SUBJECT: Vance County; Western Outer Loop from SR 1128 (Ruin Creek Road) to
SR 1101 (Old Country Home Road) near Henderson; Project No.
8.2390201; TIP Project No. U-2527

Re: Certification Pursuant to Section 401 of the Federal Clean Water Act, Tar-Pamlico Protected Riparian Buffer Certification for Modification to Western Outer Loop from SR 1128 (Ruin Creek Road) to SR 1101 (Old County Home Road) near Henderson, TIP U-2527, Federal Aid Project STP-0509(2), State Project No. 8.2390201, WQC Project No. 031494, Vance County.

Reference the Department of the Army permit issued on March 25, 2004, for construction of the Western Outer Loop of Henderson (T.I.P. No. U-2527), crossing Red Bud Creek, unnamed tributaries, and an adjacent wetland, from SR 1128, to SR 1101, southwest of Henderson, in Vance County, North Carolina. Reference also your written request of July 9, 2004, subsequently modified on August 27, 2004, for permit modification to impact an additional 26 linear feet of stream. These necessary impacts are depicted on the contract construction drawings, but were not included in the permit application drawings.

SITE 6
 PLAN VIEW

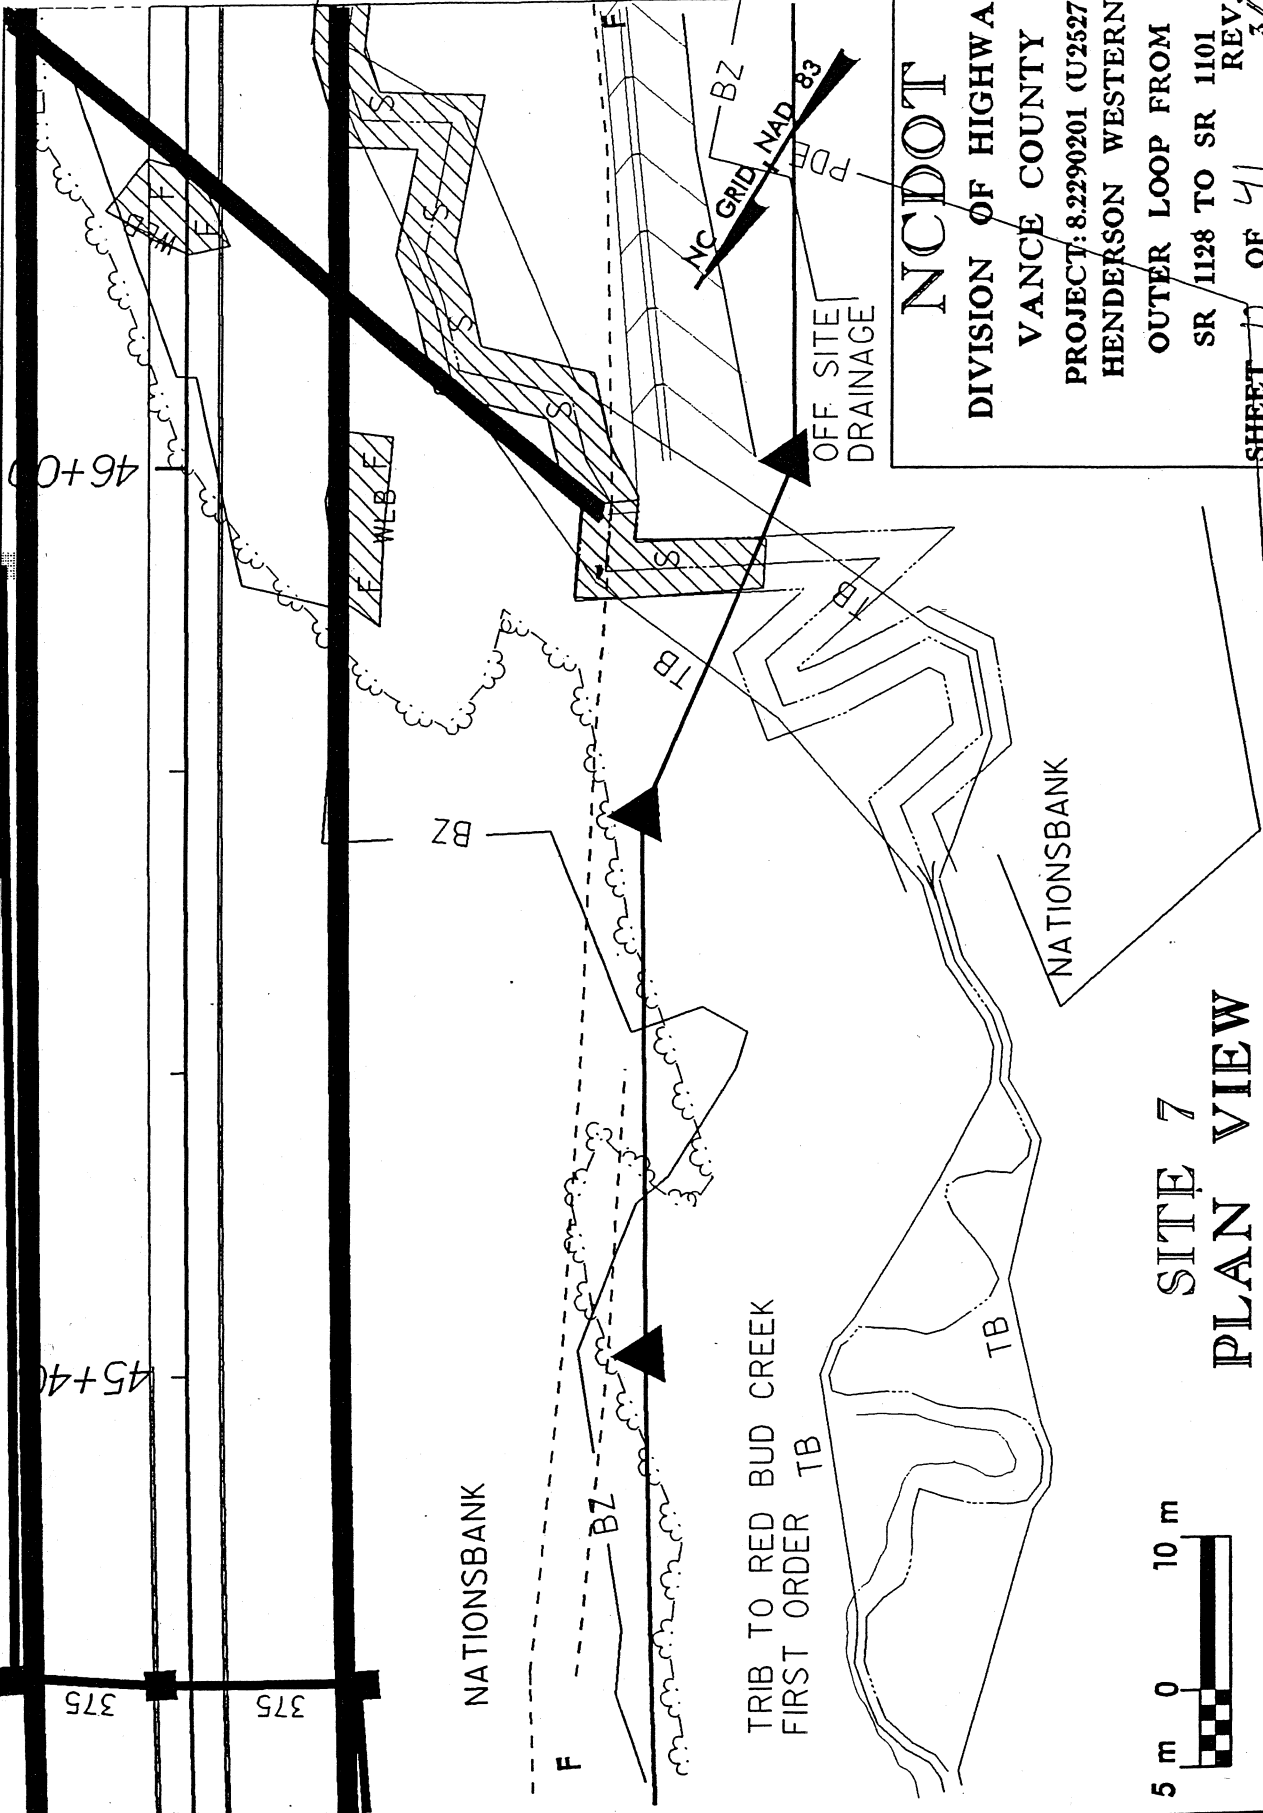
The permit is hereby modified to include the work as shown on the enclosed modified drawings. Ten linear feet of additional on-site mitigation will be required for the ten linear feet of additional impact to the perennial stream at Site 6. It is understood that all conditions of the original permit remain applicable, with the exception of Special Conditions j and k, which are modified as shown below, and that the expiration date is unchanged.
